Office Action Summary

10/582,046

STROBEL, GUSTAV

8. **Claims 12-15, 20 and 21 are rejected under 35 U.S.C. 103(a) as being unpatentable over EP 1,340,697 (Weldner) in view of U.S. Patent No. 6,234,743 (Strobel).**

Annotated Figure 3 (Weldner)

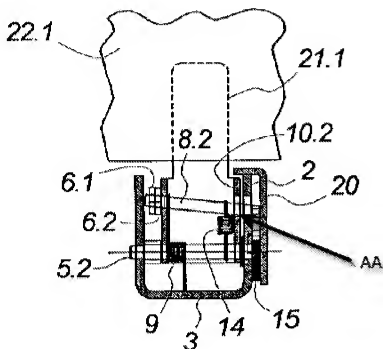
Regarding **Claims 12, Weldner** teaches: **Claim 12** – a stacking column comprising two side walls (2) and a plurality of latches (21.1-21.3) arranged between the side walls (2), wherein each latch (21.1-21.3) is integral with a pin (5.1-5.3) which allows for rotation between a rest position into a working position, (Figures 1-4); wherein a cutout portion (area between side walls (10.3) and holes (AA)) exposes a circumferential surface of the pin (5.3), and a pin holder (hole in bottoms of bottom of side wall (10.3)) which surrounds the circumferential surface of the pin (5.3), (Figure 1 and Annotated Figure 3 Below); **Claim 14** – wherein at least two adjacent pins (5.1-5.3) maintain a distance from each other which is greater than the material thickness of the latch in the region of the pin holder (hole in bottoms of bottom of side wall (10.3)), (Figures 1-3); **Claim 15** – wherein the latches (21.1-21.3) are of a single-piece design, (Figures 1-3).

Weldner does not teach the pin holder having an arcuate inner surface which only partially surrounds not more than half of the circumferential surface of the pin in an arcuately curved manner (**Claim 12**); and wherein at least two pins maintain a distance from each other which is greater than and substantially the same as a material thickness of the latch in the region of the pin holder (**Claim 14**). However, **Strobel** teaches: **Claim 12** - a stacking column comprising two side walls (2 and 3), a plurality of latches (4) arranged between the side walls (2 and 3), wherein each latch (4) is integral with a pin (11.1 and 11.2) which allows for rotation of the latches (4) between a rest position and a working position (See the "BACKGROUND OF THE INVENTION" section of the specification), (Figures 1-3); wherein the bottom portion of the latch has hole (10) for engaging the pin (11.1 and 11.2) and additionally has an arcuate surface (BB) which

Regarding **Claims 13, 20 and 21, Weldner as modified by Strobel** teaches the stacking column as described above, in addition to **Weldner** teaching: **Claim 13** - wherein the latches (21.1-21.3) are assigned a locking device (6.1-6.3, 8.1-8.3, 12.1-12.4 and 13.1-13.4) which fixes at least some of the latches (21.1-21.3) in the working position, (Figures 1-4); **Claim 20** – wherein a stop lug (10.2) projects from the upper part of the cutout (AA) to stop part of the locking device (8.2) from leaving the cutout (AA), (Annotated Figure 3 Above); **Claim 21** – wherein the locking device (8.2) moves (up and down) in the cutout (upper and lower portions of hole (AA)) by means of a small rail (8.2), (Figure 4 and Annotated Figure 3 Above).
